Model: DVPS-360, DVPS-560D**No.** 65**Subject:** REPLACING THE OPTICAL PICKUP**Date:** June 15, 2000**Symptom:**

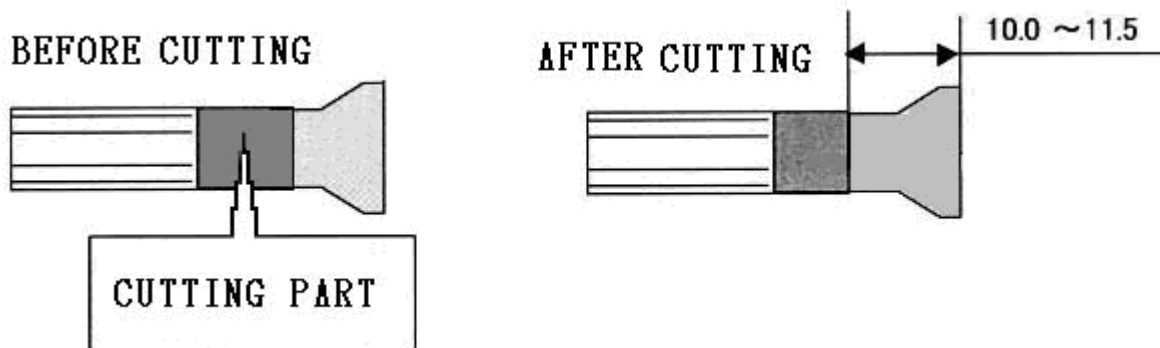
(****) Some of the Optical Pickup replacement KHM-220AAA/J1RP may need reinforcement boards to be cut smaller. The reinforced board may interfere with the Optical Pickup. If this is the case, please check and do the following.

Solution: Please confirm the reinforced board that is attached to the 23 Pin- Flexible Cable, which is connecting to the Optical Pickup. Cut the part of the reinforced board shown below. When cutting, avoid damage to other signal lines, cut only the board. After cutting, it has to be 10.0 - 11.5 (mm) if you measure the length of the reinforced board from the point of the Flexible Cable.
